MARYLAND STATE DEPARTMENT OF HEALTH

*Serial # Bro 112567
Addition - kitchen & deck*

HOUSE LOCATION SURVEY LOT-23, BLOCK "B" SECTION FOUR, AREA TWO BEAUFORT PARK HOWARD COUNTY, MARYLAND

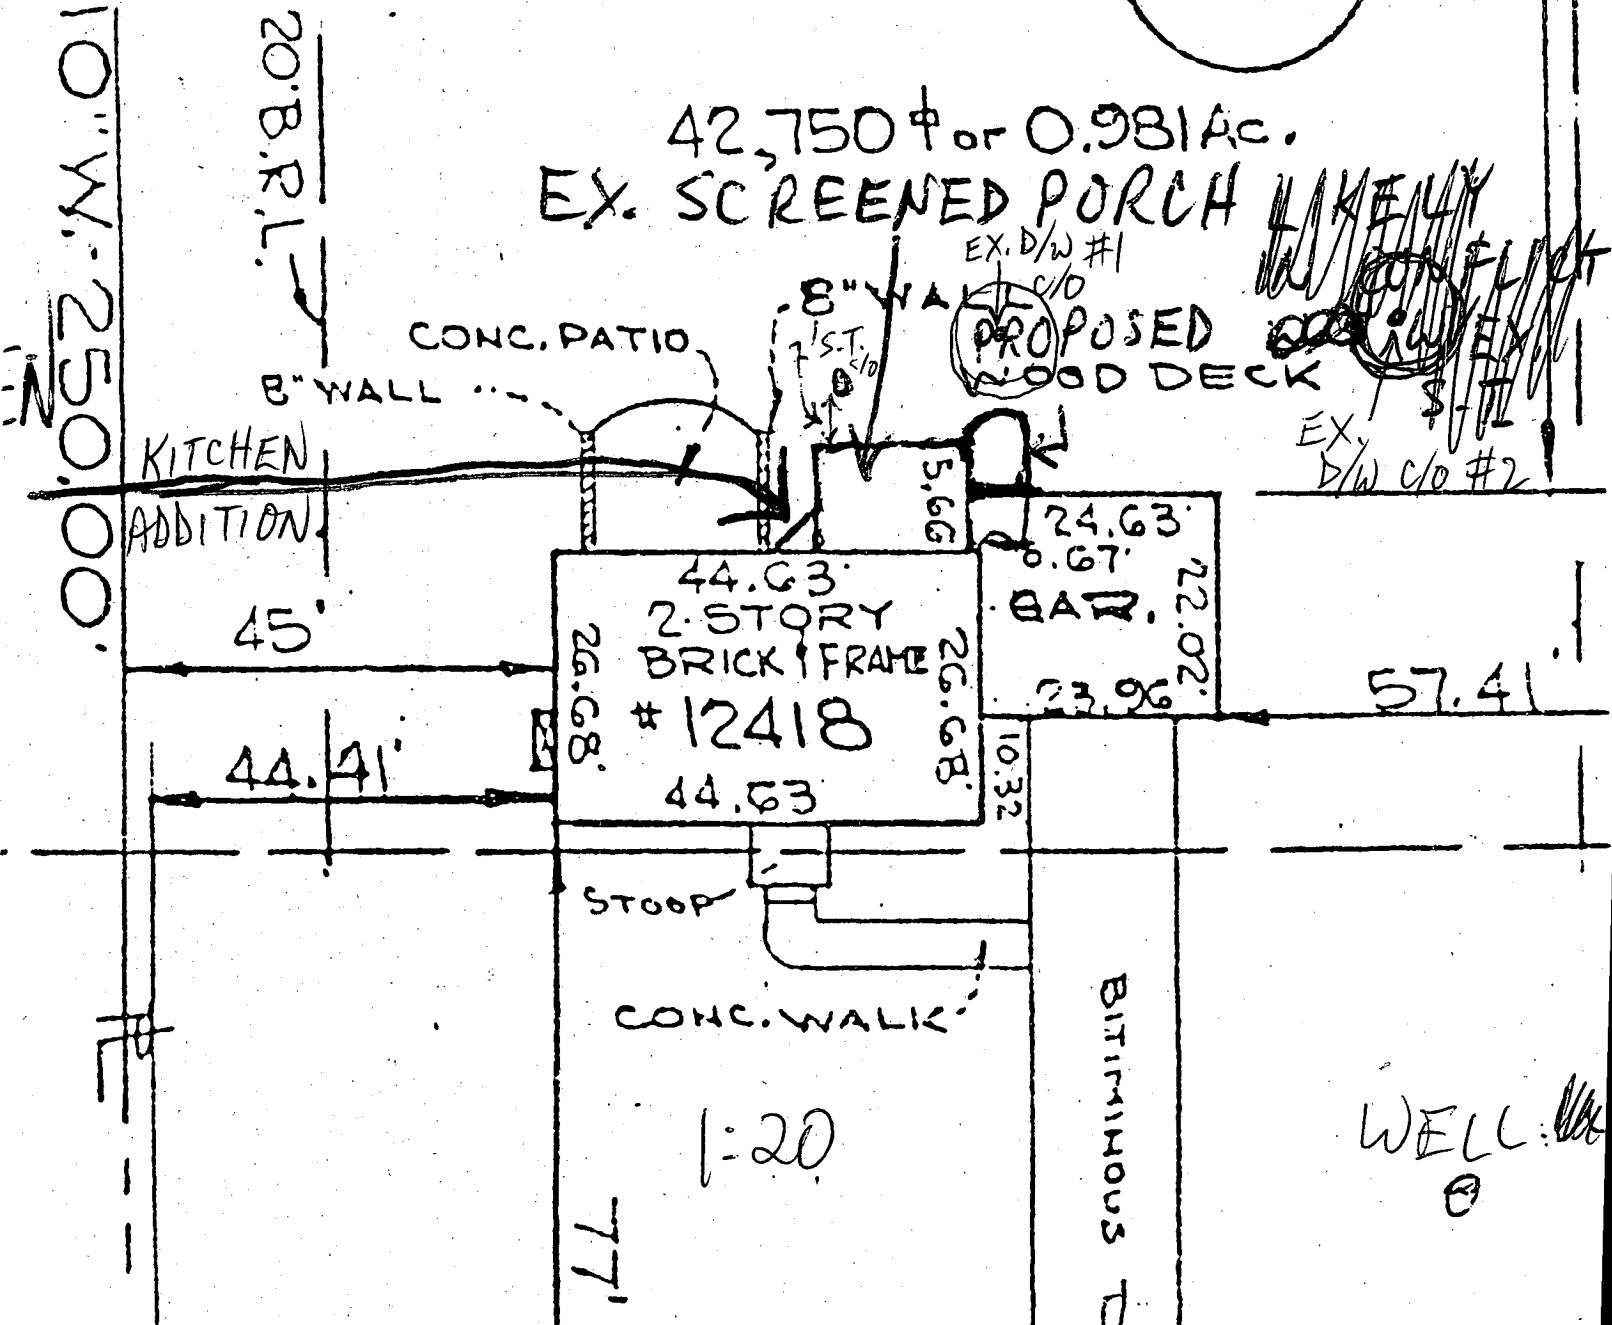
7/16/22/98 MTG W/HOMEOWNER & CONTRACTOR S.T. 7' FROM SCREENED PORCH w/BRICK FOUNDATION - ACCEPTED; EX D/W LOC. ~2' FROM PROPOSED DECK. ADVISED ~~OTHERS~~ THEM DECK DESIGN REQUIRES D/W ABANDONMENT & REPAIR TO SEPTIC; ALTERNAT- 50' B.R.L.

INELY, NO CLOSER THAN EXISTING SCR. PORCH; EITHER WAY, KITCHEN ADD'N LOT - 23 OF REPAIR PROMISE OK; OWNER TO SUBMIT LETTER IF DECK IS DESIRED

6/29/98 LETTER REC'D, OK; BP SIGNED
